Microcontroller Technical Information

32-Bit Microcontrollers V850E/MA3 Usage Restrictions		Document No.	ZBG-CC-07-0025	1/1
		Date issued	December 18, 2007	
		Issued by	2nd Product Solution Group Multipurpose Microcomputer Systems Division Microcomputer Operations Unit NEC Electronics Corporation	
Related documents	V850E/MA3 Hardware User's Manual: U16397EJ V850E1 Architecture User's Manual: U14559EJ	Notification classification	√	Usage restriction
				Upgrade
				Document modification
				Other notification

32-Bit Microcontrollers V850E/MA3 Usage Restrictions

List of Usage Restrictions in V850E/MA3

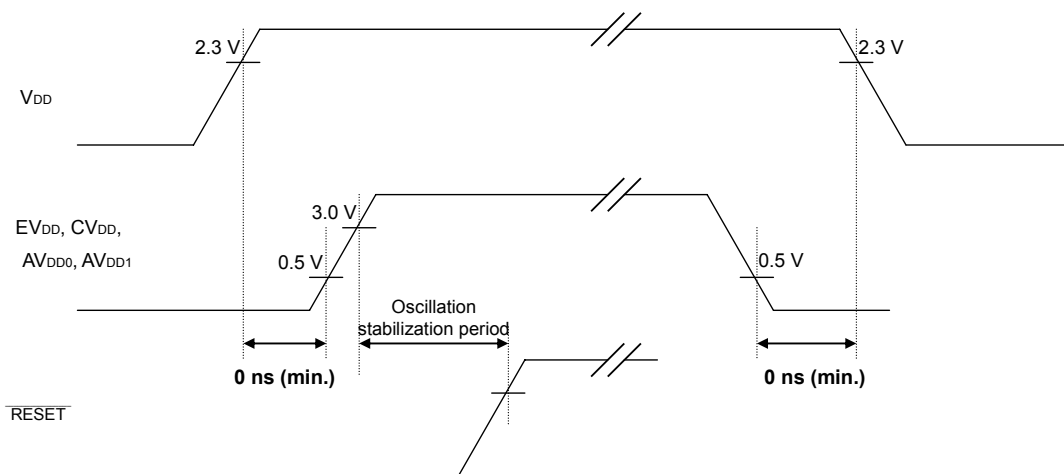
When turning on/off the power, if the voltage on the internal power supply pin (V_{DD}) exceeds the operation guaranteed range (2.3 to 2.7 V) while the voltage has been applied to the external power supply pins (EV_{DD} , CV_{DD} , AV_{DD0} and AV_{DD1}), the following operations may occur.

- A current of approximately 130 mA (typ.) may flow into the EV_{DD} pin.
- An undefined value may be output from the following pins.

TDO/ $\overline{TC3}$ /P27 pin

ANO0/P80 pin

ANO1/P81 pin

To avoid this bug, it is recommended to turn on or off the power in the procedure shown below.

<When turning on power>

Keep the voltage on the EV_{DD} , CV_{DD} , AV_{DD0} , and AV_{DD1} pins at 0.5 V or lower until the voltage on the V_{DD} pin reaches the operation guaranteed range (2.3 to 2.7 V).

<When turning off power>

Keep the voltage on the V_{DD} pin to within the operation guaranteed range (2.3 to 2.7 V) until the voltage on the EV_{DD} , CV_{DD} , AV_{DD0} , and AV_{DD1} pins drops to 0.5 V or lower.

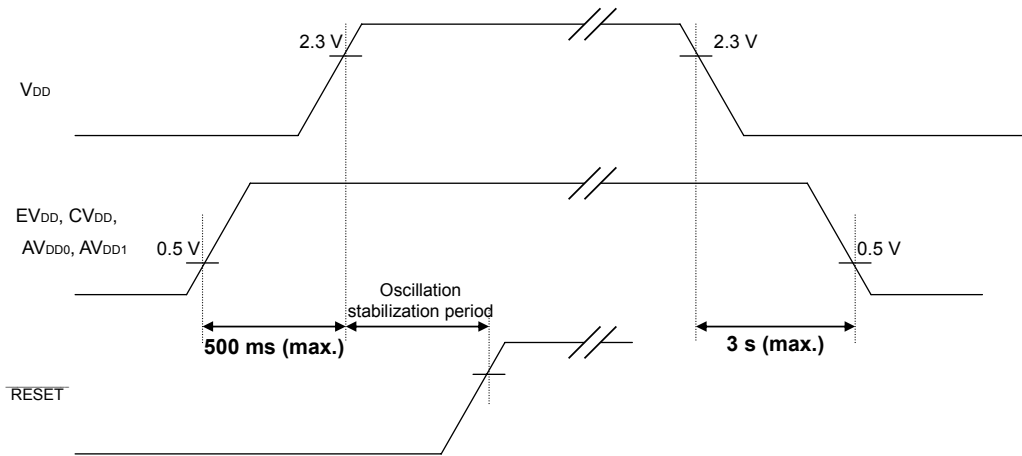
[Caution]

Also observe the timing shown below when turning on/off the power to the external power supply pins (EV_{DD}, CV_{DD}, AV_{DD0} and AV_{DD1}) before turning on/off the power to the internal power supply pin (V_{DD}).

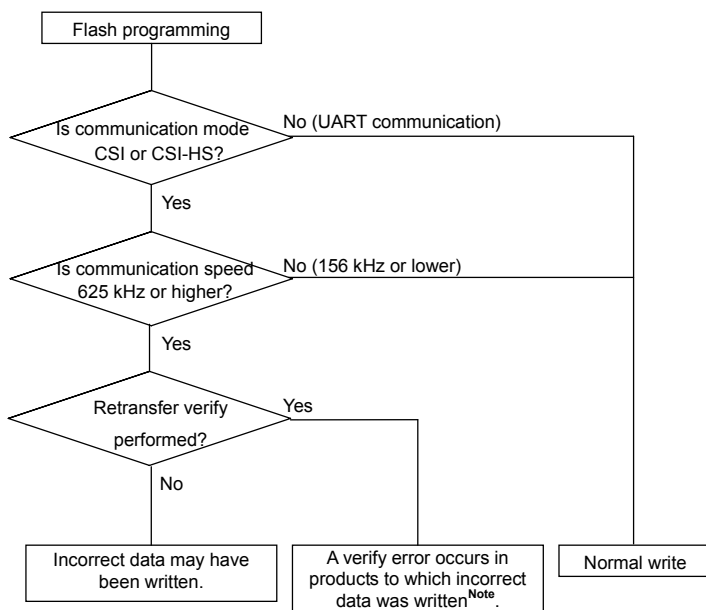
When programming to flash memory is performed using flash programmer PG-FP4, unexpected data may be written. If verify (set by selecting “Read verify after Program” in the PG-FP4 setting screen) is not executed, operation ends without causing an error even if unexpected data is written, so erroneous programming cannot be detected. If verify is executed, a verify error occurs and thus erroneous programming can be detected.

Erroneous programming may occur if PG-FP4 communication is performed in CSI or CSI-HS mode, with a 625 kHz or higher communication speed.

[Verify setting]

To enable verify, select the “Read verify after Program” check box on the PG-FP4 GUI software screen. Refer to the PG-FP4 user’s manual for details.
